Subject: Mechatronic Transmission Module (MTM) Update – Endurant HD and PACCAR TX-12

Document Number: TAIB-1001

Date: July 1, 2022

Updated: 4/12/2024

MTM Type Configuration in ServiceRanger:

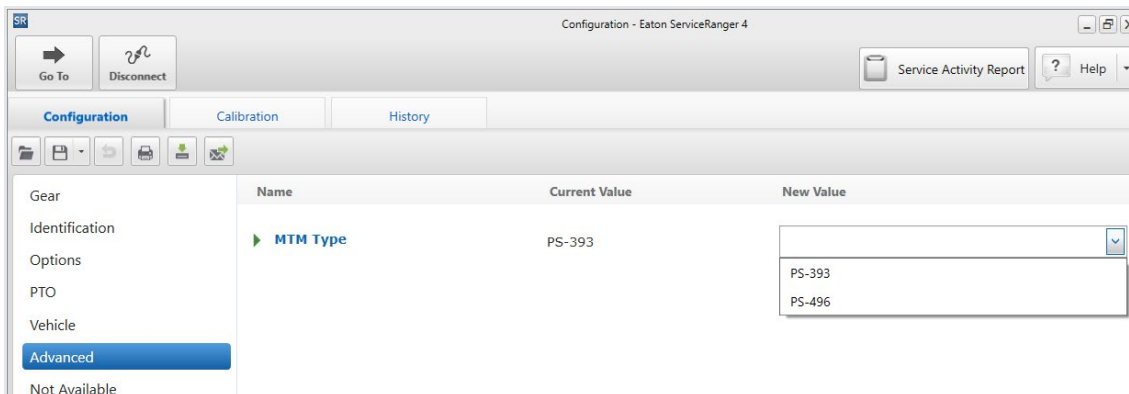
- Configuration parameter added to TCM software – MTM Type with the following settings:
 - PS-393 (Original)
 - PS-496 (New)
 - When TCM software is updated to 5516042 or greater on original equipment units the MTM Type is set to PS-393.

- Service Manual (TRSM0950):
 - If an original equipment MTM (PS-393) is replaced with an updated MTM (PS-496), the MTM Type configuration must be changed in the TCM with ServiceRanger.

1. Key on
2. Connect ServiceRanger
3. Go To “Configuration”
4. Select “Advanced”
5. From the New Value dropdown, select MTM Type based on MTM part number.
6. Select “Apply” (lower right) and follow on-screen prompts.
